Access Compliance Report

Public Rights-of-Way

Intersection ID: 18216	Main Street: FOREST_DR	Cross Street: S_WENDOVER_RD	Location:	N
ADA ID: 9969E3D5344A	Ramp Type: PerpDiag	Initial Pass/Fail: Fail	Overall Compliance: No	Severity Score: 12.5

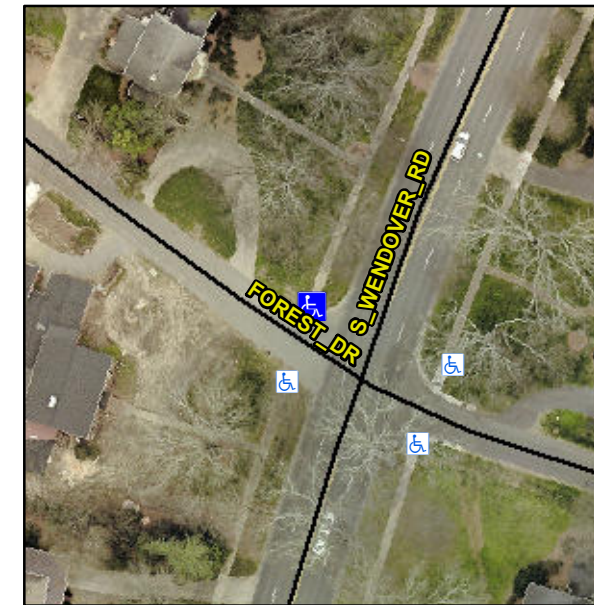
Not Found, R304.2.2

Compliance	Description	Data	Compliance	Description	Data
N/A	Ramp Length (in)	63.0	No	Ramp Slope (%)	8.9
Yes	Ramp Width (in)	48.0	Yes	Ramp XSlope (%)	1.1
N/A	Flare Type LT	N/A	N/A	Flare Type RT	N/A
N/A	Flare Slope LT (%)	N/A	N/A	Flare Slope RT (%)	N/A
N/A	Flare Traversable LT?	N/A	N/A	Flare Traversable RT?	N/A
N/A	Landing Length (in)	N/A	N/A	DWS Provided?	N/A
N/A	Landing Width (in)	N/A	N/A	DWS Contrast?	N/A
N/A	Landing Slope (%)	N/A	N/A	DWS Length (in)	N/A
N/A	Landing X Slope (%)	N/A	N/A	DWS Full Width?	N/A
N/A	Landing Curb? (Y/N)	N/A	N/A	DWS Offset (in)	N/A
N/A	Shared Landing?	N/A			
N/A	Gutter Ponding?	N/A	N/A	Gutter Slope (%)	N/A
N/A	Gutter Lip Ht (in)	N/A	N/A	Gutter X Slope (%)	N/A
N/A	Painted X Walk1?	No	N/A	Painted X Walk2?	No
	X Walk 1 Direction	To SW		X Walk 2 Direction	To SE
N/A	X Walk 1 Width (in)	N/A	N/A	X Walk 2 Width (in)	N/A
	X Walk 1 Slope (%)	2.8		X Walk 2 Slope (%)	2.4
	X Walk 1 X Slope (%)	2.0		X Walk 2 X Slope (%)	1.8

Remove & Replace Curb Ramp With Two New Directional Ramps or Equivalent.
